Corridor Cities Transitway Briefing

Completed: 01/21/2016

Review of CCT Preliminary Engineering Plans (approximately 30% design level)

Summary of Staff Comments on CCT 30% Design Plans for Forwarding to MTA and MCDOT

Figure 1 – CCT Alignment on Darnestown Road Avoiding JHU Belward Campus

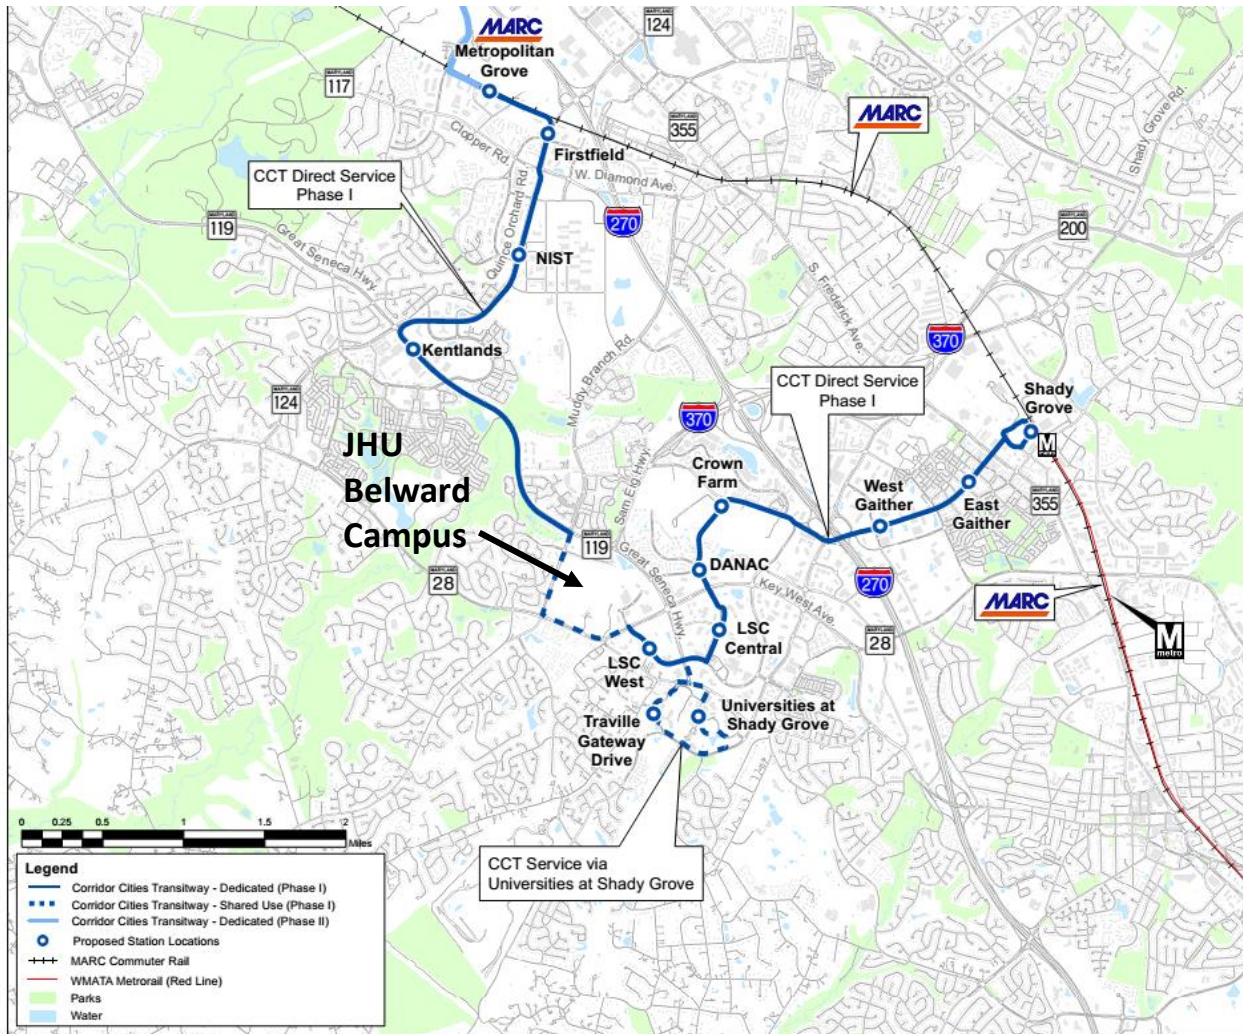
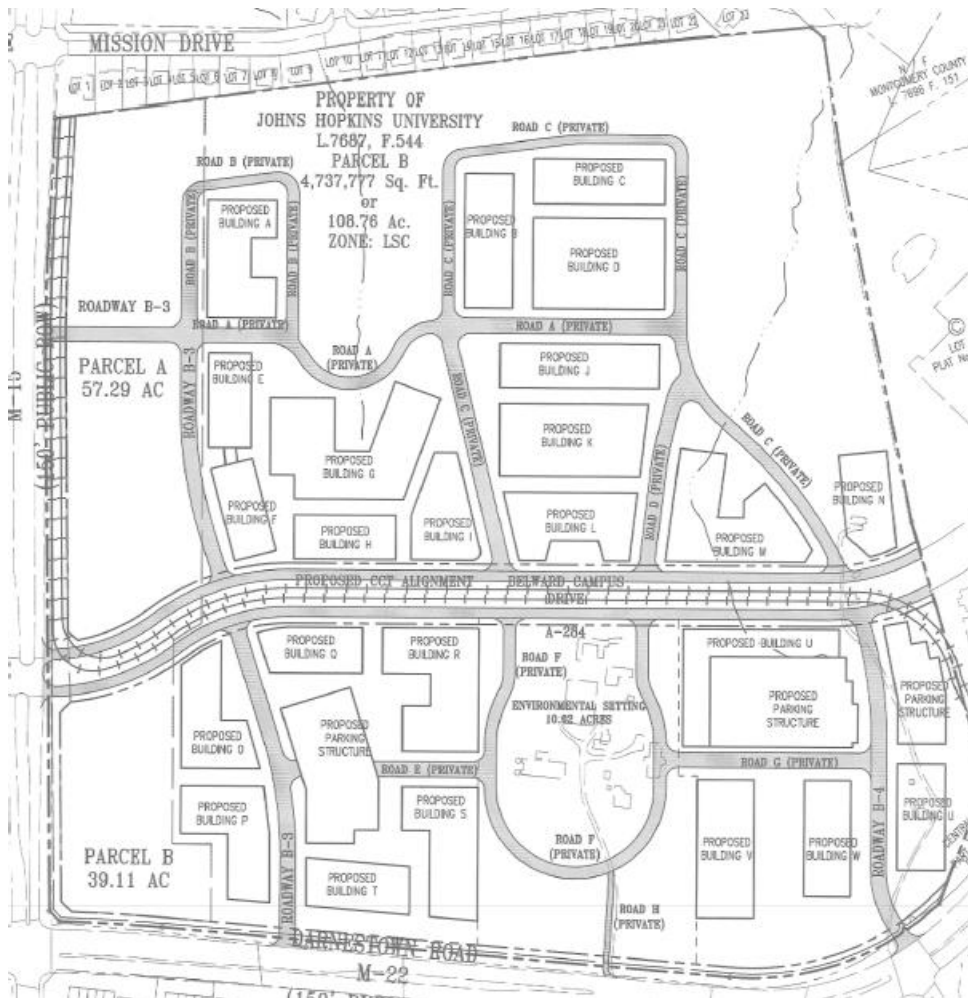
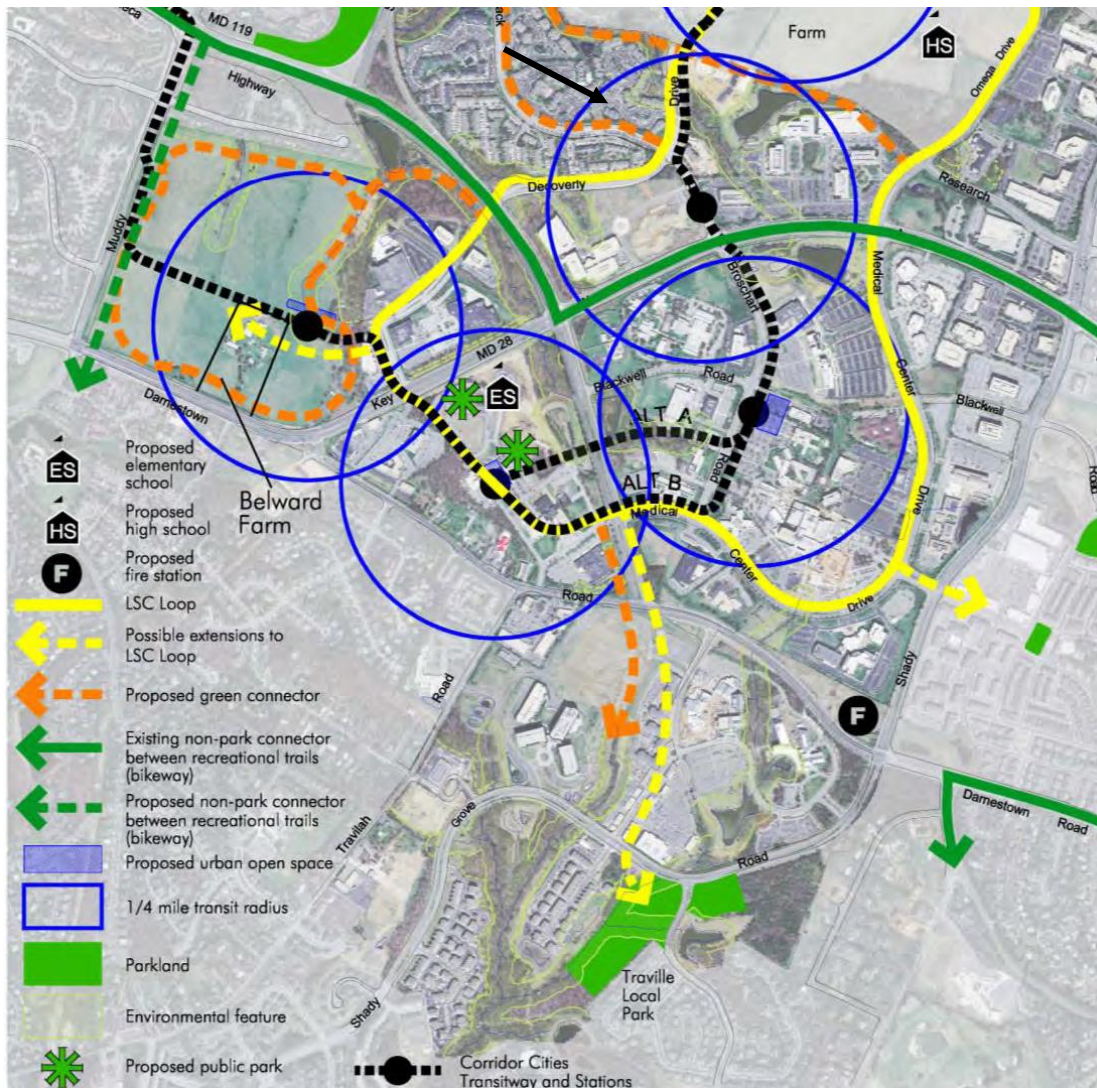
The MTA’s 30% preliminary engineering plans that avoid Belward Farm, therefore, are not consistent with the GSSC Master Plan or the approved JHU Belward Campus Preliminary Plan Amendment.³

- 1. The MTA's 30% preliminary engineering plans that avoid Belward Farm are not consistent with the GSSC Master Plan or the approved JHU Belward Campus Preliminary Plan Amendment.**

Figure 4 – Shady Grove Metro Station (Existing and Future with CCT)

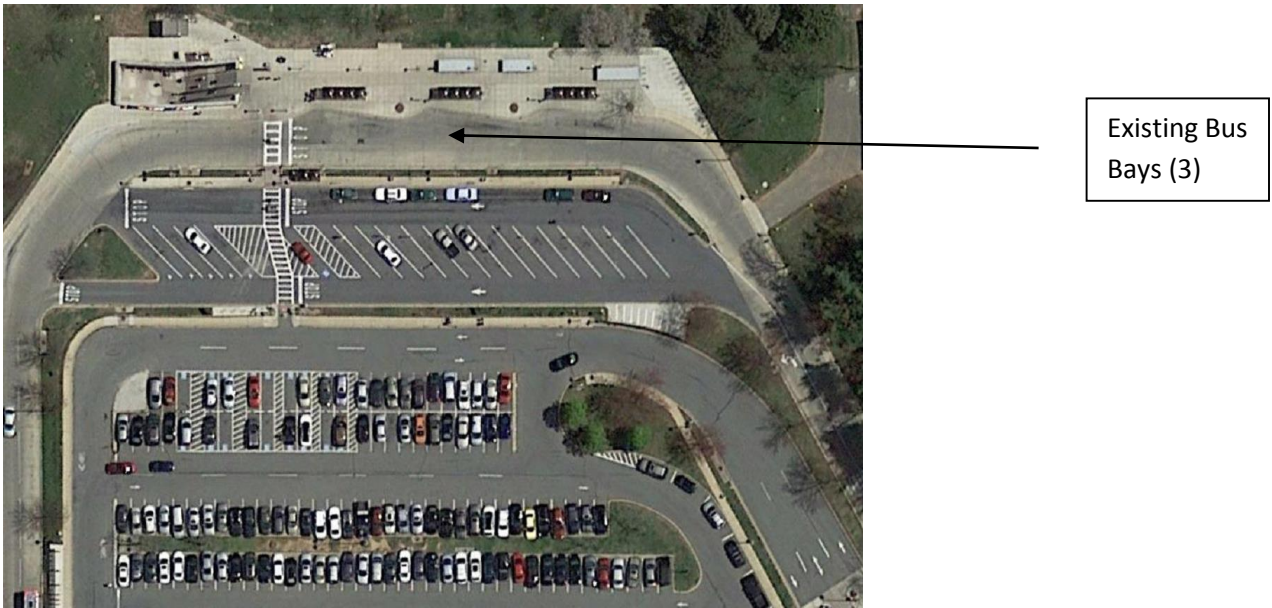
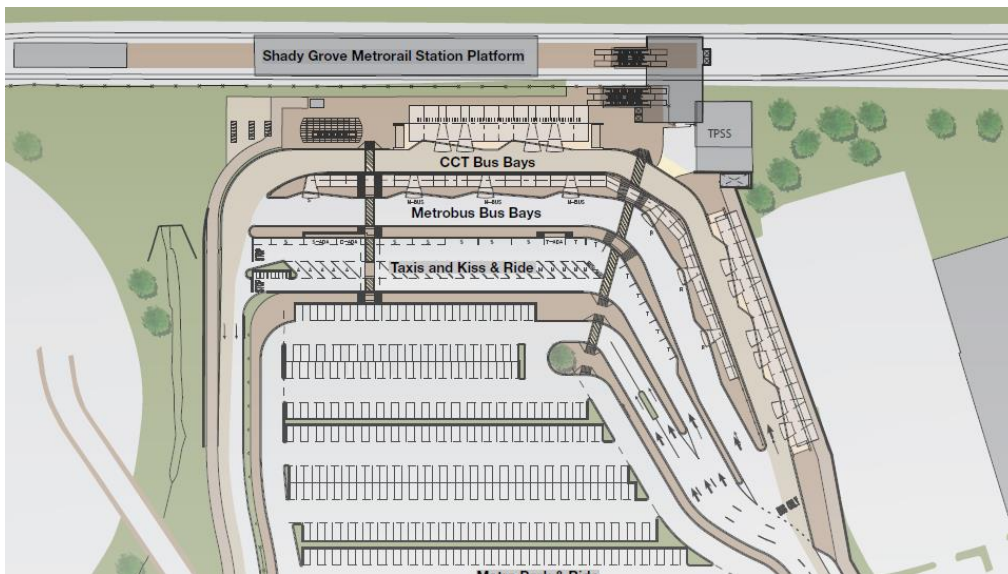
The Washington Metropolitan Transit Authority (WMATA) recently (September 2015) completed the Shady Grove Station Capacity Improvements Study that examined a number of aspects of the station capacity – both now and in the future and with and without the CCT and other BRT routes. One aspect included a preliminary analysis of the adequacy of bus bays with the CCT in the future (2030). The analysis indicated that with the construction of the CCT and the associated five bus bays on the west side, there would be “adequate bus bays and layover spaces both on the east and west sides of the Shady Grove Metrorail Station in 2020 with and without the CCT and in 2030 with the CCT.”⁶ The analysis appears to indicate at one point that a total of 12 bus bays (for either bus in active service or laying over) would be needed on the west side and if so, that slightly exceeds the total of 11 now in the CCT plans.⁷ One of the 11 bays in the CCT plan is dedicated to shuttle providers and it is unclear if that requirement was factored into the WMATA preliminary analysis. **Staff recommends that MTA and WMATA continue to coordinate on the number of bus bays required at the Shady Grove Station as there may be slightly differing estimates between the CCT plan and the recently completed WMATA preliminary analysis of future bus bay requirements.**

- 2. The MTA and WMATA should continue to coordinate on the number of bus bays required at the Shady Grove Station as there may be slightly differing estimates between the CCT plan and the recently completed WMATA preliminary analysis of future bus bay requirements.**

Figure 5 – Metro West Neighborhood (Shady Grove Sector Plan – 2006)

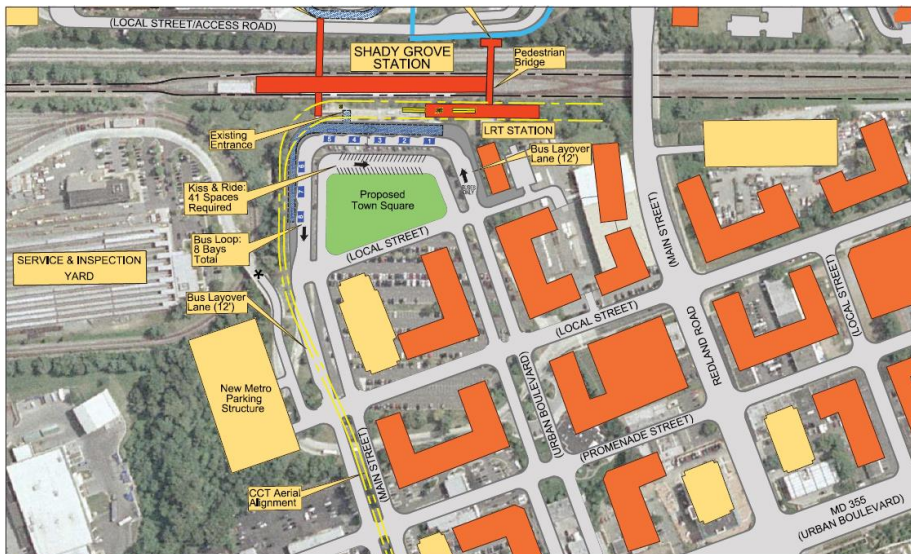
The need for the additional drive aisle and boarding area for the CCT result in the kiss and ride and taxi space being relocated or shifted an estimated 55-60 feet to the west toward Frederick Road. This result in a smaller surface parking area and begins to impact an area designated as a Proposed Town Square in the 2006 Shady Grove Sector Plan (see Figure 5).

There are no active development plans for the area where the surface parking lot is currently located. Any plan under consideration would require agreement with WMATA as the land owner and was also require close coordination with the MTA CCT design team and the County to insure consistency with the CCT plans and the 2006 Shady Grove Sector Plan. **Staff therefore recommends the MTA remain in frequent contact with both WMATA and the County (and vice-versa) as development plans in the immediate station area (especially on the west side) are introduced at a concept level, refined and finally submitted. The need for the expansion of the bus bays on the west side to accommodate a BRT CCT will result in a slightly different footprint or concept than the one presented for the Metro West Neighborhood in the 2006 Shady Grove Sector Plan.**

- 3. The MTA should remain in frequent contact with both WMATA and the County (and vice-versa) as development plans in the immediate Shady Grove station area (especially on the west side) are introduced at a concept level, refined, and submitted. The need for the expansion of the bus bays on the west side to accommodate a BRT CCT will result in a different footprint or concept than the one presented for the Metro West Neighborhood in the 2006 Shady Grove Sector Plan.**

Figure 6 – North Frederick Road / Metro Station Access Road Plan with CCT

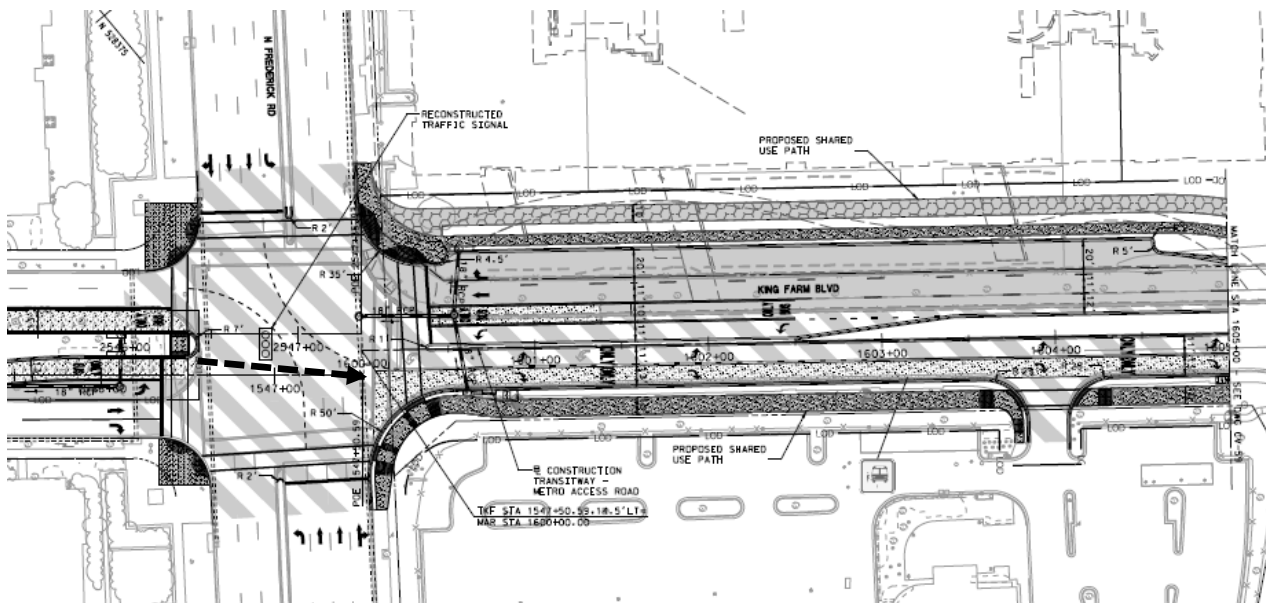
The CCT will cross North Frederick Road (MD 355) at-grade – taking advantage of a separate signal phase at the intersection to transition to and from the exclusive lanes on King Farm Boulevard. The existing Metro Station Access Road on the east side of North Frederick Road will be widened to the south to accommodate the bus lanes. The CCT lane configuration (as shown below in Figure 6) will be slightly off-set in the eastbound direction (see heavy dashed line) to accommodate the separate through and turn lanes as well as the shared use path on the south side of the Metro Station Access Road. The eastbound BRT will advance across North Frederick Road (MD 355) during a separate signal phase. **Because of space constraints in this location, staff recommends the MTA continue close coordination with the Planning Department and the City of Rockville related to development applications in the southeast corner of this intersection.**

- 4. Because of space constraints at the intersection of Frederick Road and King Farm Boulevard, staff recommends the MTA continue close coordination with the Planning Department and the City of Rockville related to development applications in the southeast corner of this intersection.**

Figure 10 – CCT Bridge Typical Section Looking East or Toward King Farm

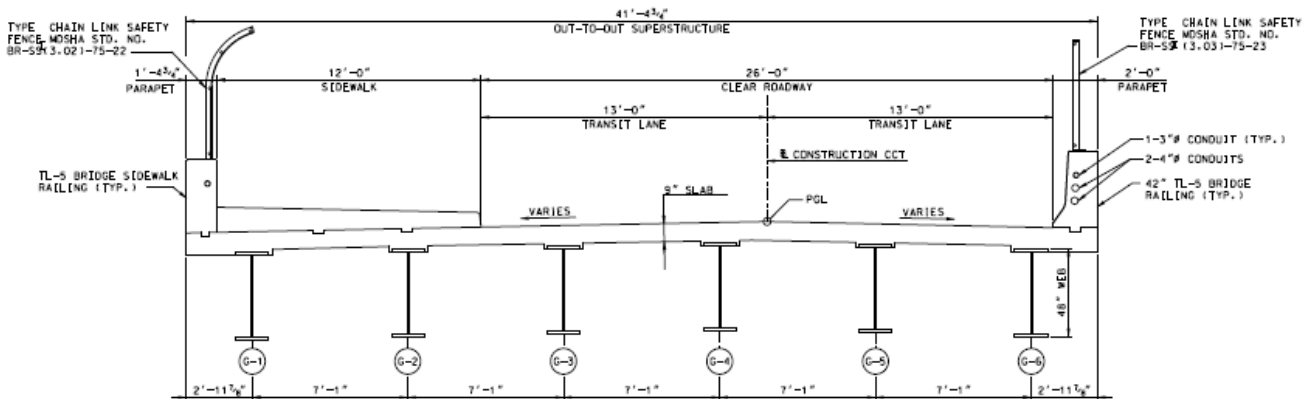
The 12' wide sidewalk connects the sidewalk in King Farm to a sidewalk on the east side of Washingtonian Boulevard. The current drawings do not reflect a barrier or buffer between the sidewalk and the transit lane on the bridge. **Staff recommends the MTA consider including a combination of protective features (railing, raised curb, pavement treatment, etc.) to delineate an area between the sidewalk and the adjacent transit lane.** An example of one type of separation used on a new bridge in Portland Oregon is shown in Figure 11 below.

- 5. Consider including a combination of protective features (railing, raised curb, pavement treatment, etc.) to delineate an area between the sidewalk and the adjacent transit lane on the bridge over I-270.**

Figure 16 – CCT in Median of Decoverly Drive with Cycle Track and Shared Use Path on East Side

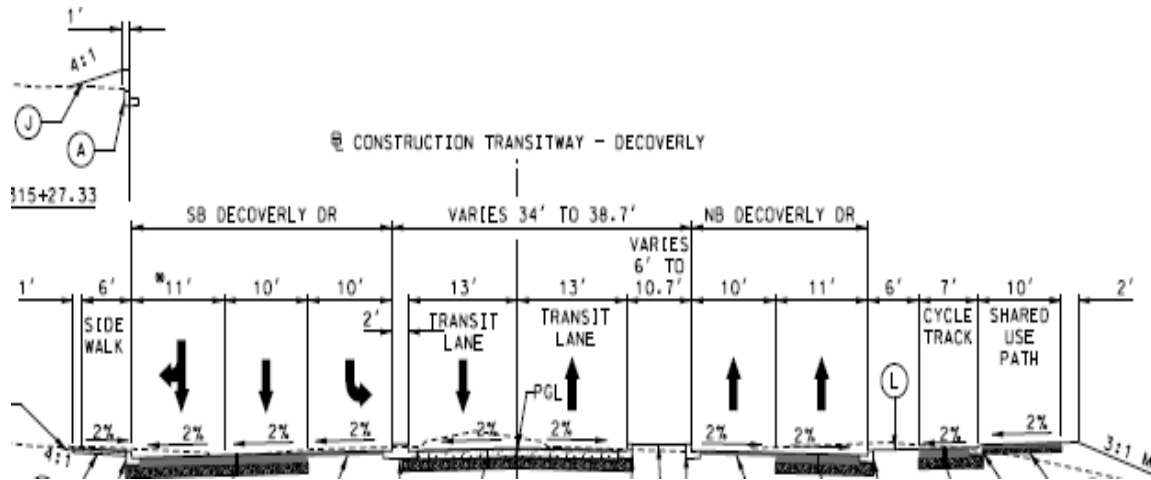
The CCT plans include a shared use path and 7-foot wide separated bike lane or cycle track on the east side of Decoverly Drive beginning at Skyhill Way and continuing south to the DANAC Station (see Figure 16 below) on Diamondback Road. **The Draft Life Sciences Center Bicycle Network Proposal recommends a protected bike lane on both sides of Decoverly Drive (one northbound as in the CCT plan and the other southbound on the west side of Decoverly Drive).** Staff recommends continued coordination with the MTA and the City of Gaithersburg on the implementation of the separated bike lanes within this section where there are few physical constraints.

- 6. The Draft Life Sciences Center Bicycle Network Proposal recommends a protected bike lane on both sides of Decoverly Drive (one northbound as in the CCT plan and the other southbound on the west side of Decoverly Drive). Continued coordination with the MTA and the City of Gaithersburg is recommended on the implementation of the separated bike lanes within this section where there are few physical constraints.**

Figure 21 – Shady Grove Adventist Hospital Preliminary Plan

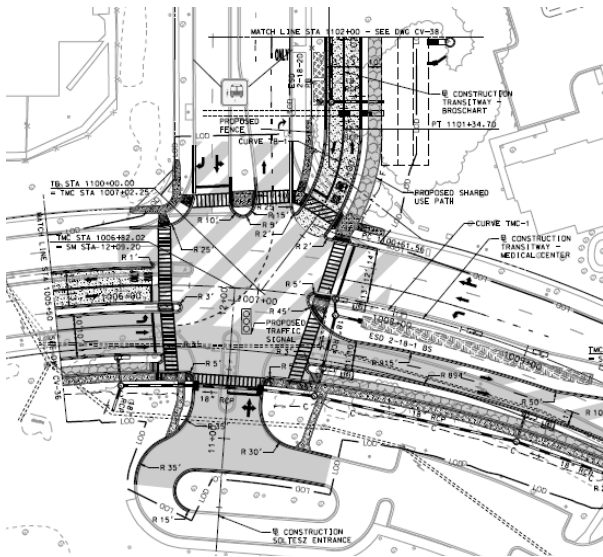
The CCT plans and the plans for the redevelopment of the Shady Grove Adventist Hospital site (Preliminary Plan 120110160) have been coordinated and include dedication for the space for the CCT on the east side of Broschart Road (see Figure 21 below). Continued coordination will be required through CCT Final Design and the consideration of the Site Plan for the hospital. There is a planned shared use path on the east side of Broschart Road from the LSC Central Station to Medical Center Drive.

- 7. The CCT plans and the plans for the redevelopment of the Shady Grove Adventist Hospital site (Preliminary Plan 120110160) have been coordinated and include dedication for the space for the CCT on the east side of Broschart Road. Continued coordination will be required through CCT Final Design and the consideration of the Site Plan for the hospital.**

Figure 23 – CCT Medical Center Drive Section

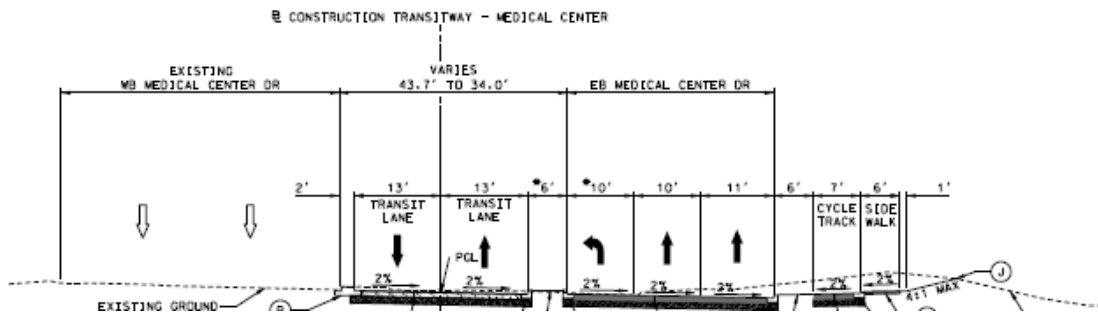
Figure 23 below reflects the typical section for Medical Center Drive between Broschart Road and Great Seneca Highway. This section includes a 7-foot wide protected bike lane or cycle track on the south (or eastbound) side. The Draft Life Sciences Center Bicycle Network Proposal includes a similar protected lane on the north or westbound side of Medical Center Drive. **The CCT 30% plans and the Site Plan Amendment for 9550 Medical Center Drive were closely coordinated. Staff recommends continued coordination during the CCT final design work.**

- 8. The CCT 30% plans and the Site Plan Amendment for 9550 Medical Center Drive were closely coordinated. Continued coordination during the CCT final design work is essential.**
